## STAFF COMMENTS

### ADDENDUM TO PREVIOUS STAFF COMMENTS PROVIDED DECEMBER 14, 2016

**Case #37-16: SITE PLAN APPROVAL  
MODIFICATION**  
50 Duchaine Boulevard  
Map: 134, Lots: 456, 457, 458 & 459

The submittal is shown as the Site Plan for 50 Duchaine Blvd (Assessors Map 134, Lots 456, 457, 458 and 459) New Bedford, MA dated November 18, 2016 prepared for Eversource Energy, P.O. Box 100085-N2, Duluth, GA 30096 by Thompson Farland 398 County Street, New Bedford, MA 02740, consisting of nine (9) sheets; and

LAYOUT

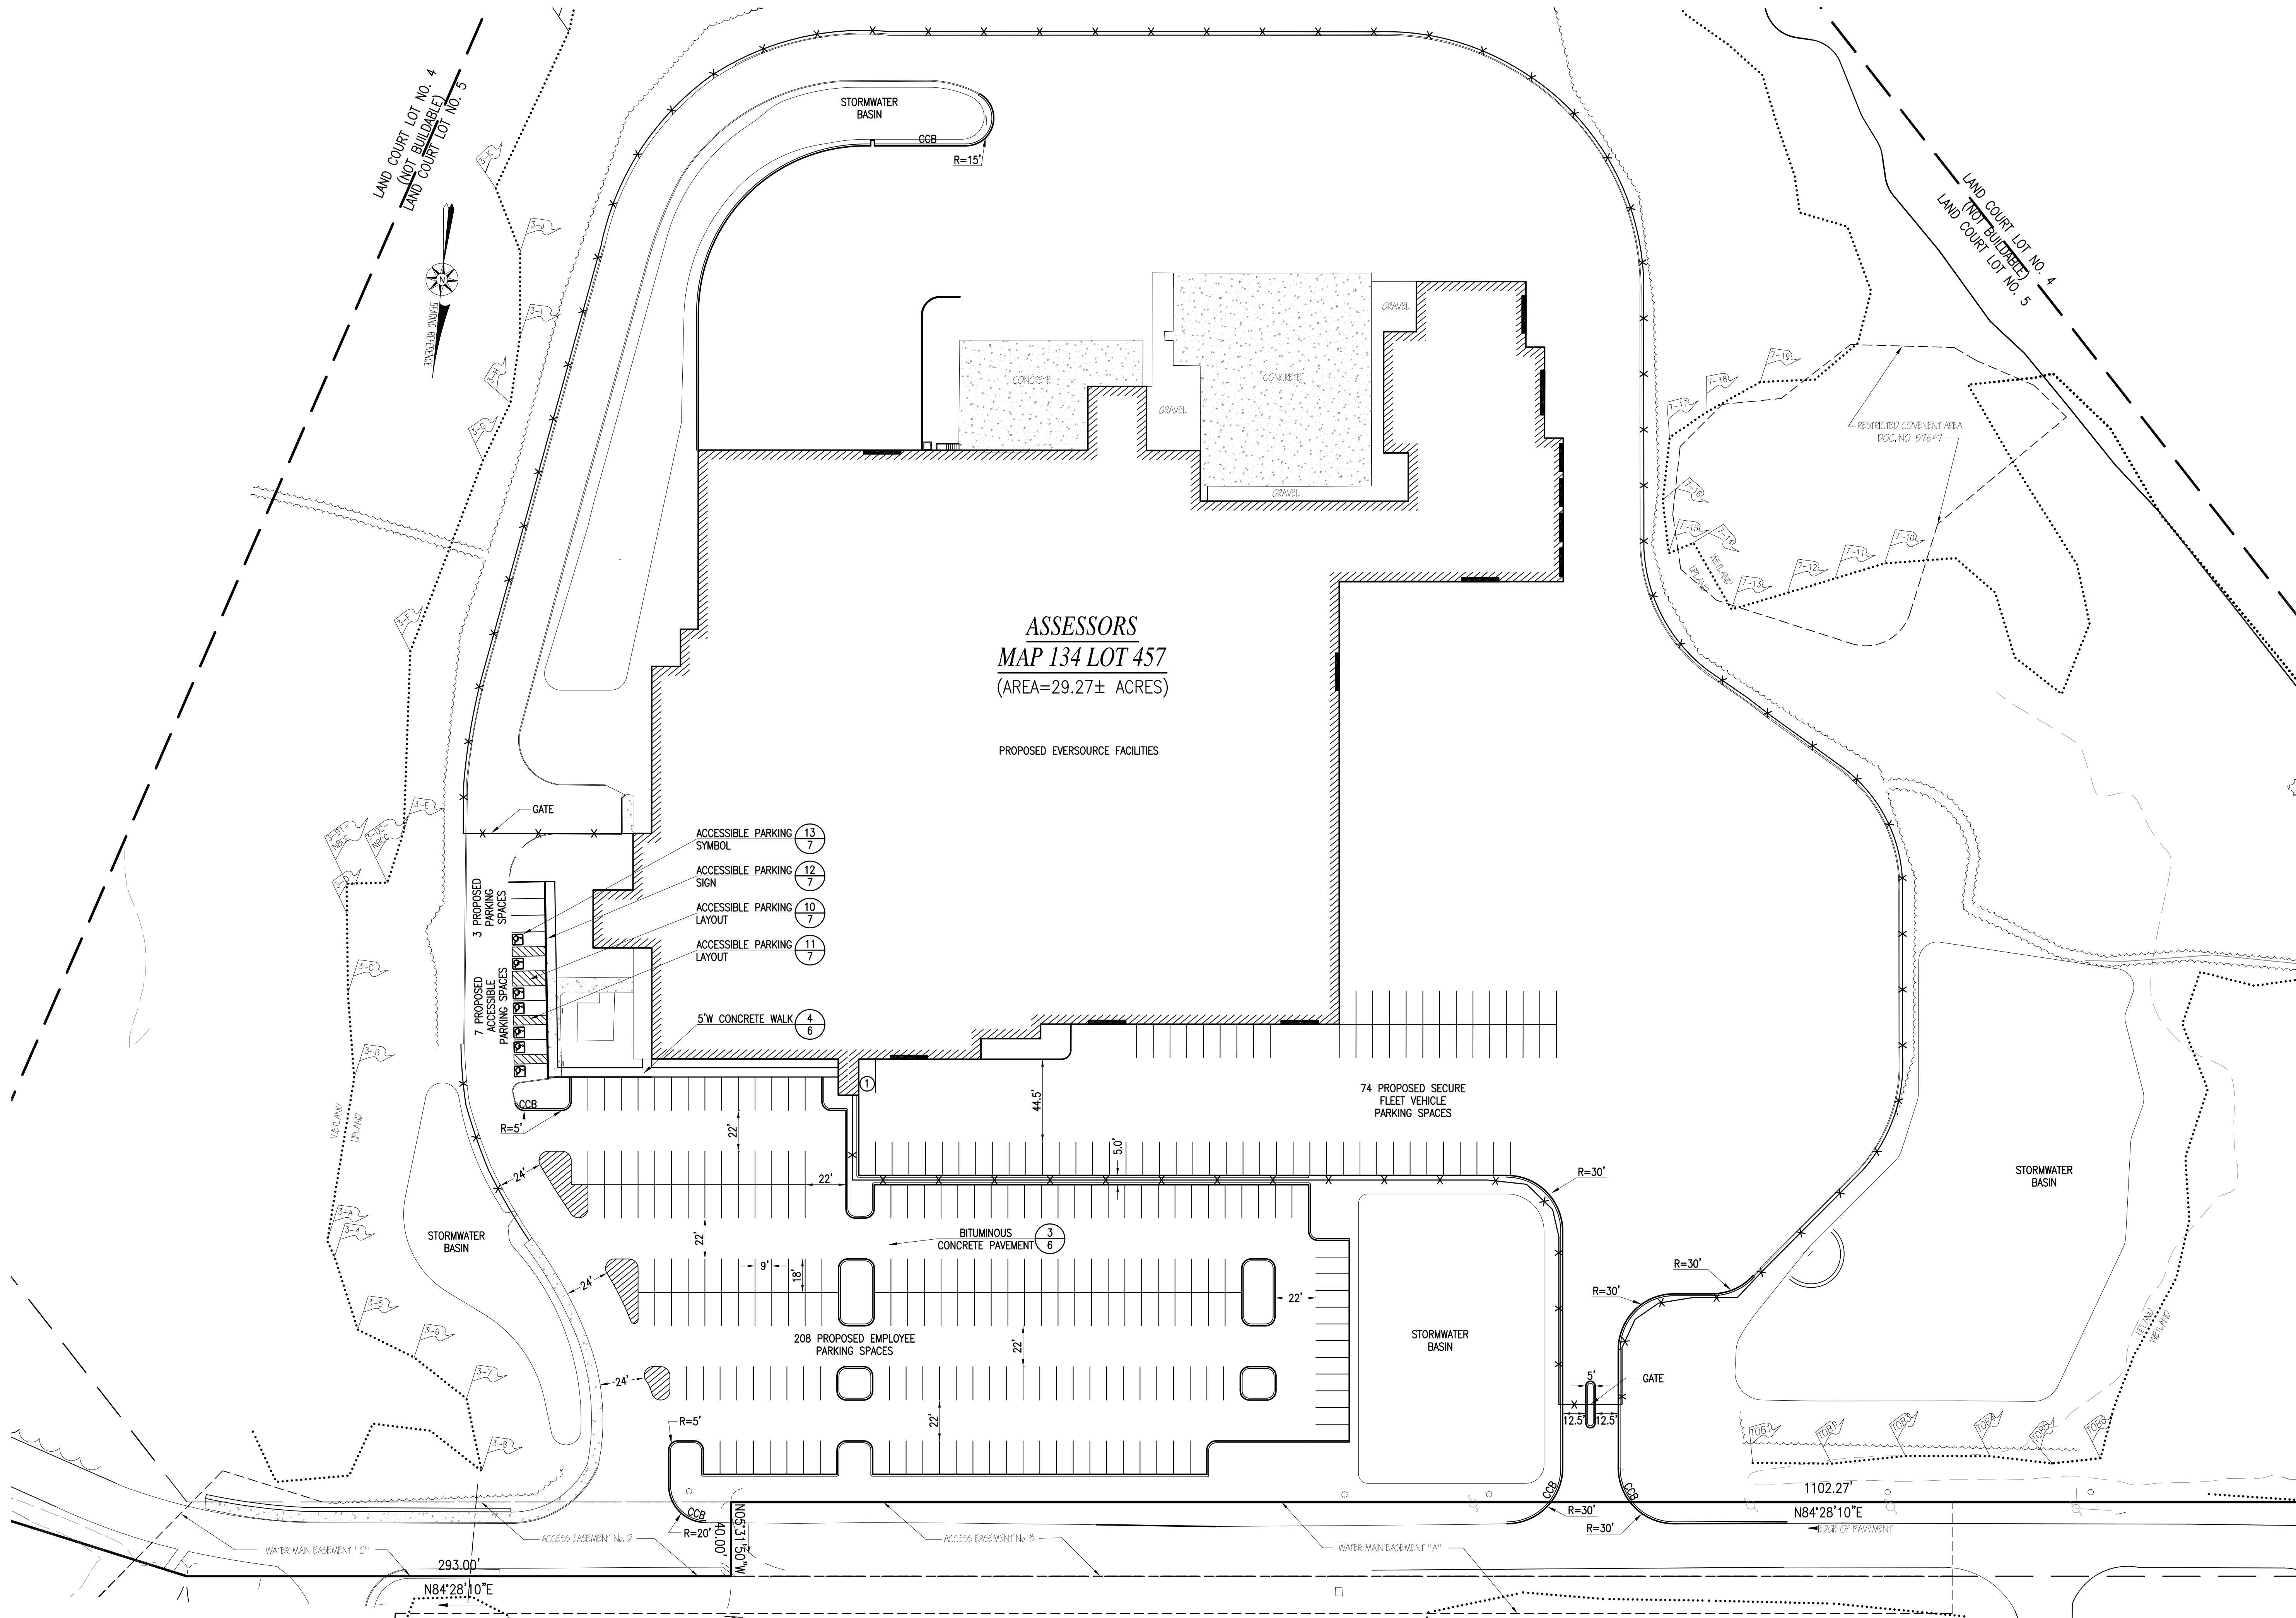
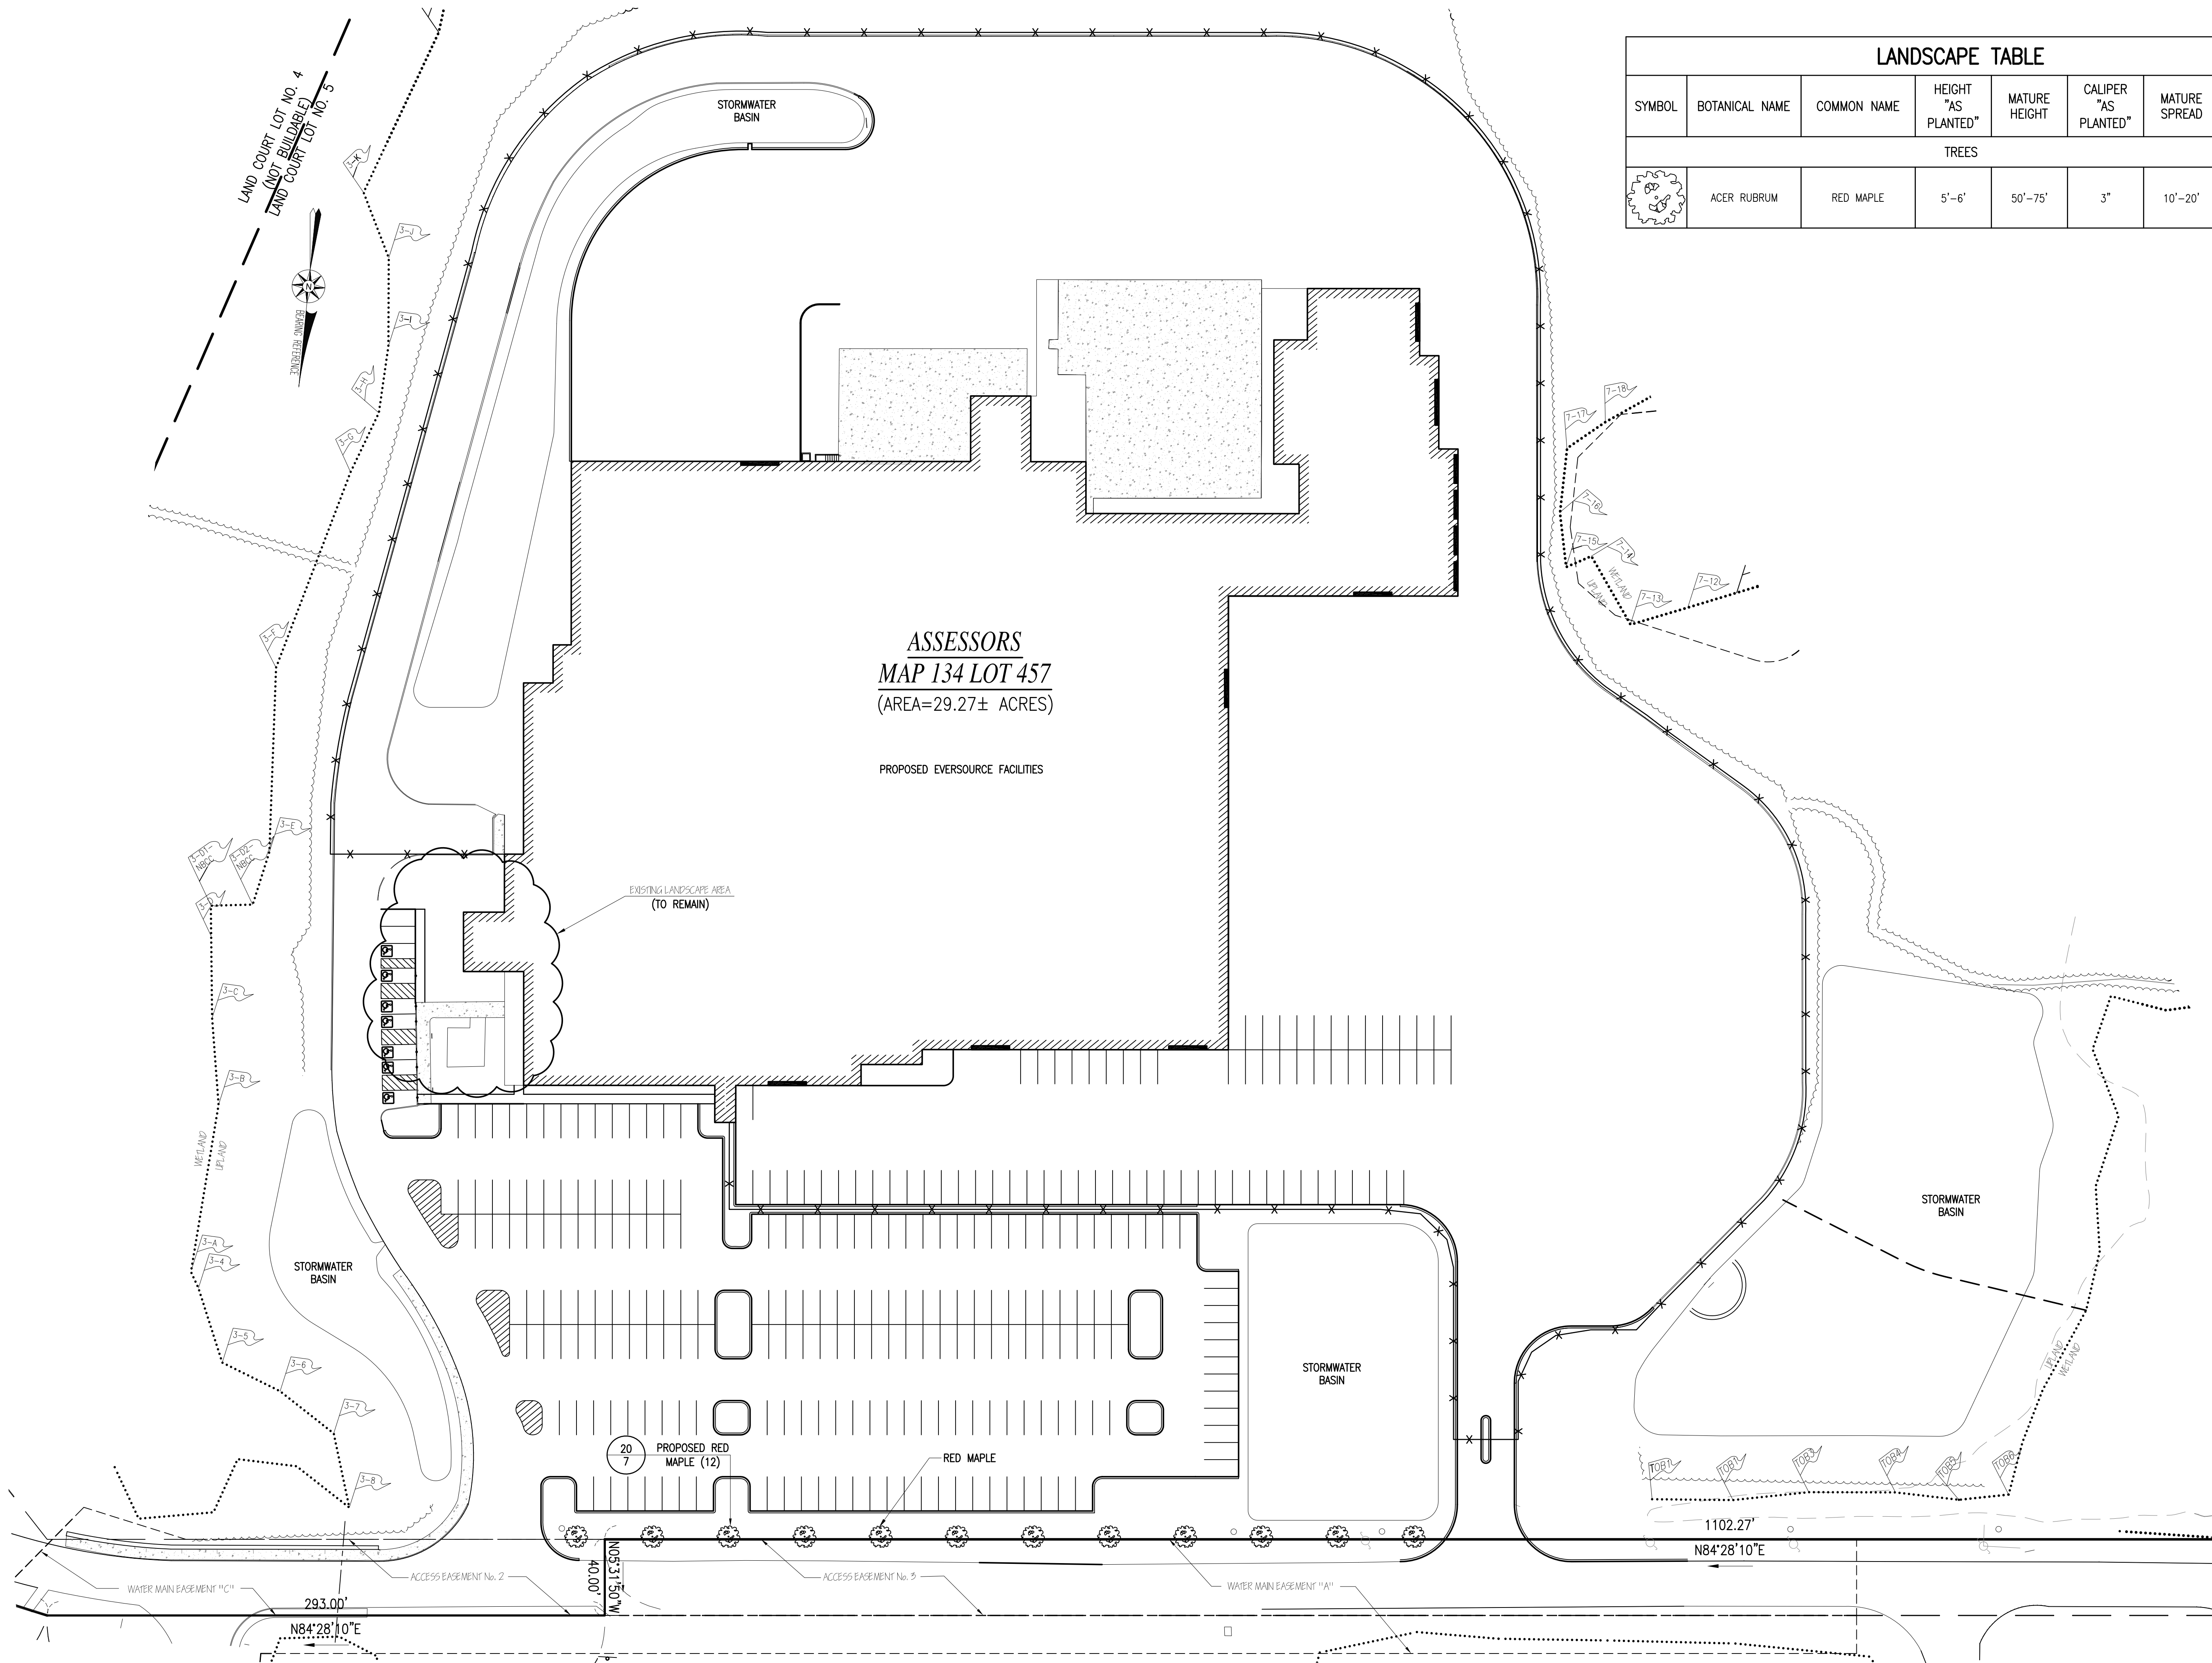
Applicant to Provide: 21E Contaminated Site Information, if applicable.  
Restrictive Covenant Doc No. 57647
- **Layout - Sheet 4 of 9**
  - Parking spaces are not dimensioned per municipal code under §3150.

LANDSCAPE

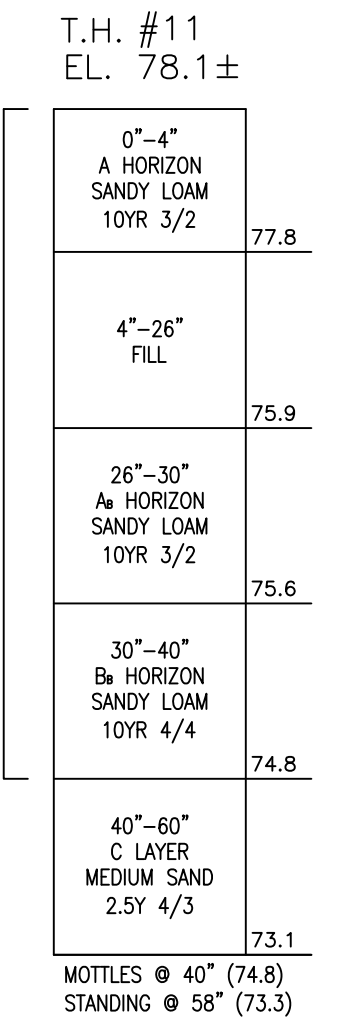
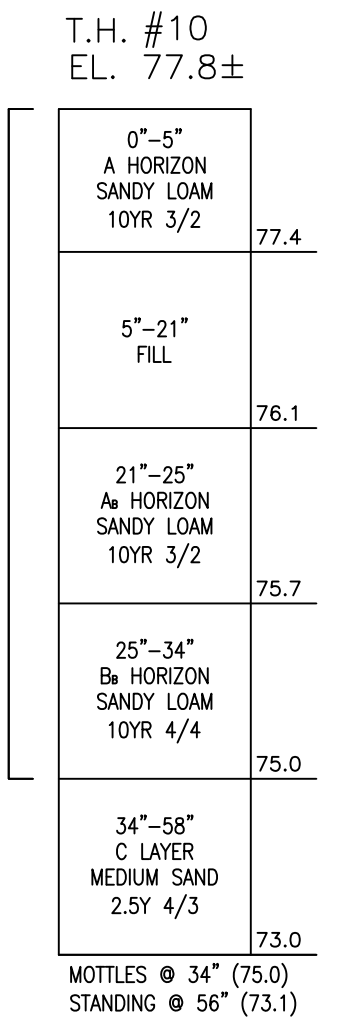
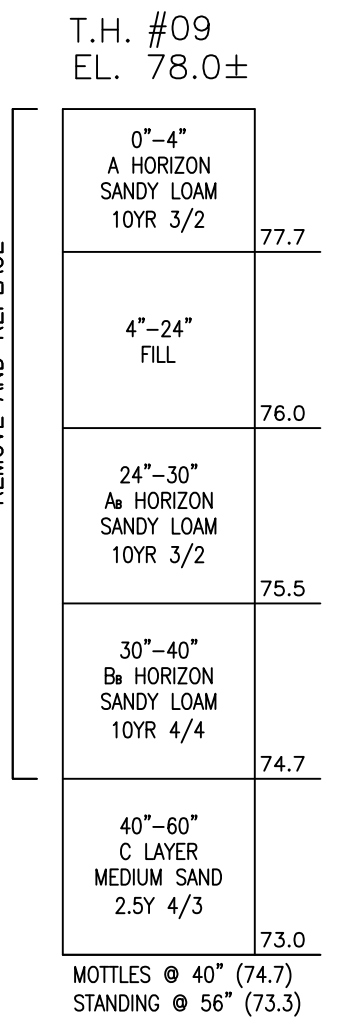
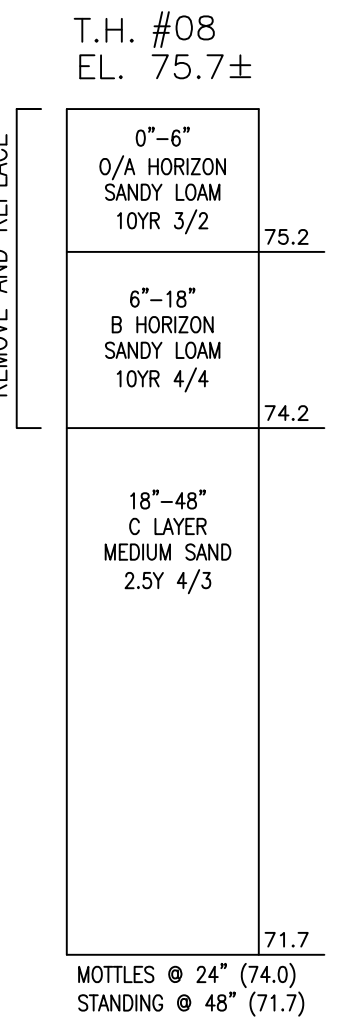
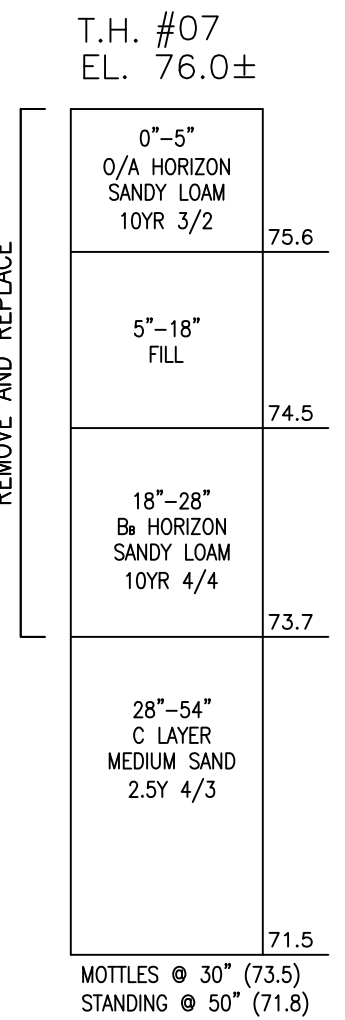
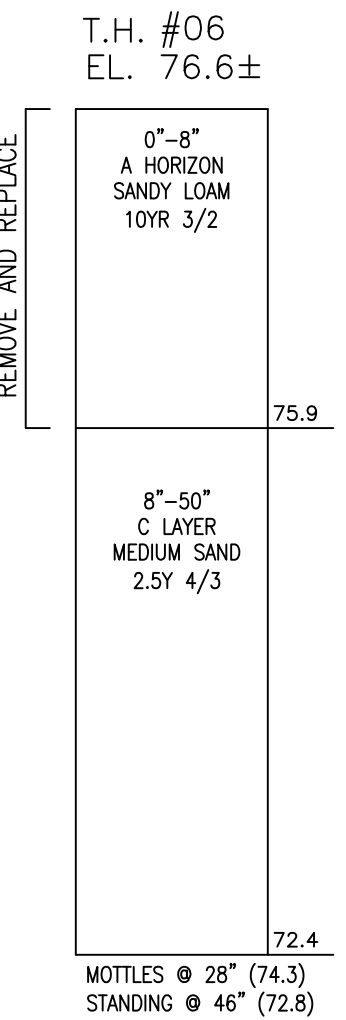
- **Grading & Utility-Sheet 5 of 9**
  - Applicant to Provide: Any Utility Easement(s).  
See Comments from DPI.
- **Landscape – Sheet 6 of 9**
  - Significant excavation has been performed at the north elevation of the building, reducing the green cover in preparation of paved parking area. Minimal landscape design has been presented to remedy this loss of vegetation.

- Given the north south orientation of the site redevelopment, the board may wish to consider requiring the applicant add landscape to islands and increase number of plantings to provide for transpiration due to reduction of green space.

- The Landscape Plan shall have a note stating period of planting to be March 15-May 15 and September 15-November 15, weather permitting.
- **Detail - Sheet 7 of 9**
